Addendum # 2

Date: August 26, 2015

PROJECT #: NT-0014-C03
Garfield James Madison Elementary School
Garfield Public Schools

DESCRIPTION: Addendum # 2

REVISED PLAYGROUND EQUIPMENT LAYOUT

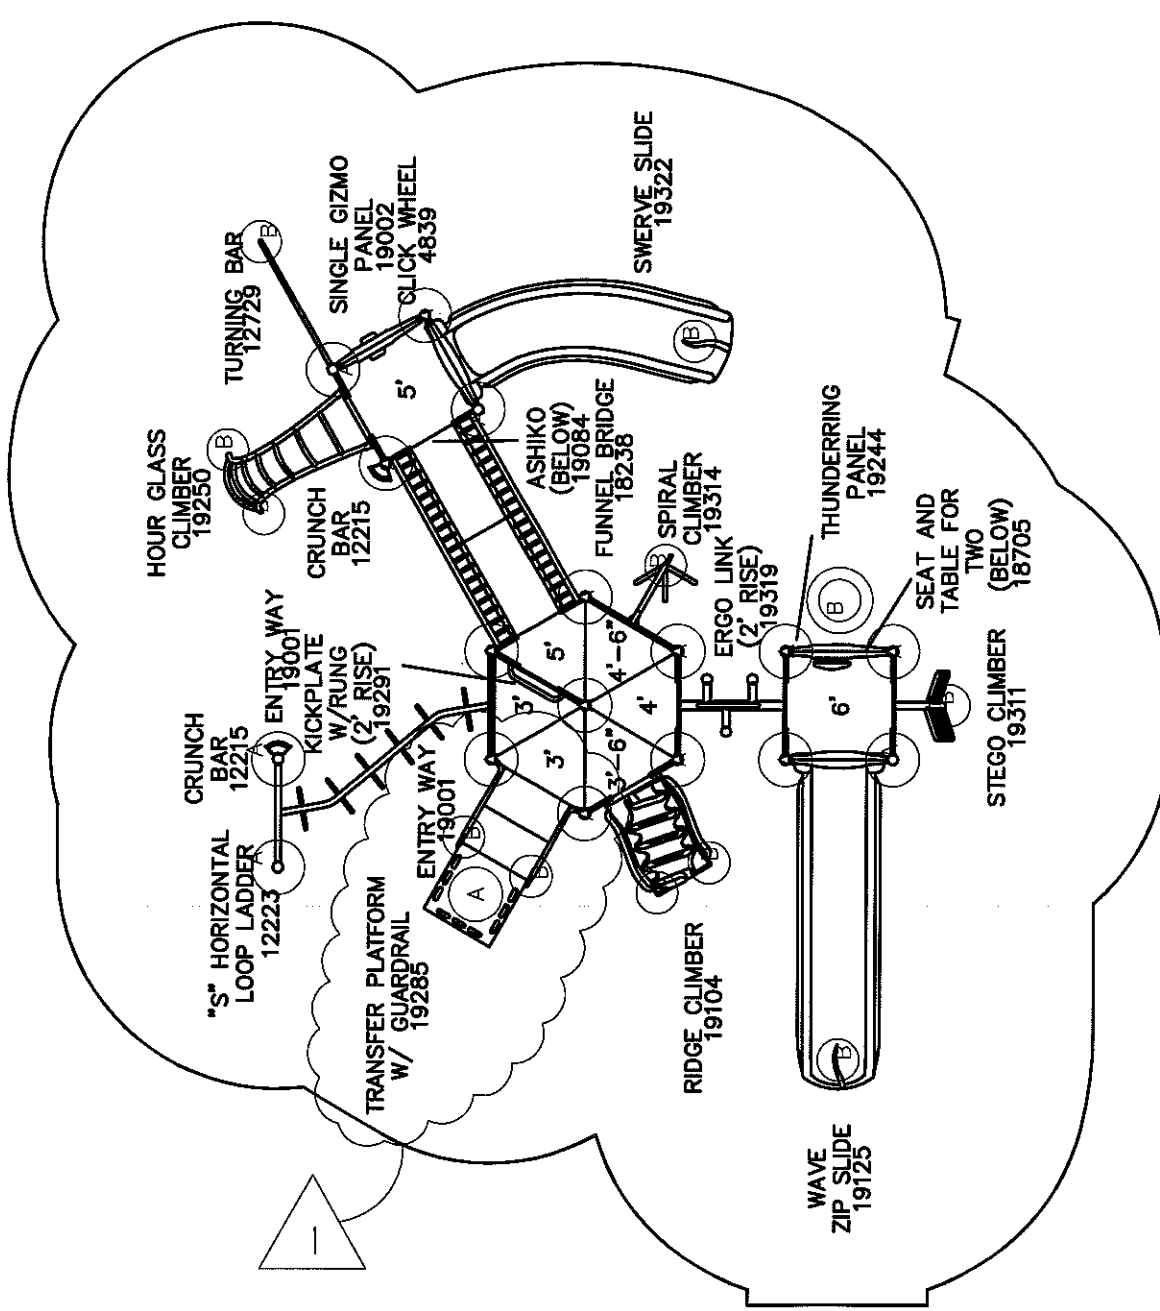
14. Question: The play Structure does not meet ADA Laws as suggested by one of the supplier. Please clarify or provide with other specs.

Answer: Provide and install Transfer Platform with Guiderail, part # 19285 and attach to the hexagon between equipment #12223 and #19104 as indicated on drawing AD2-A01, attached to this Addendum.
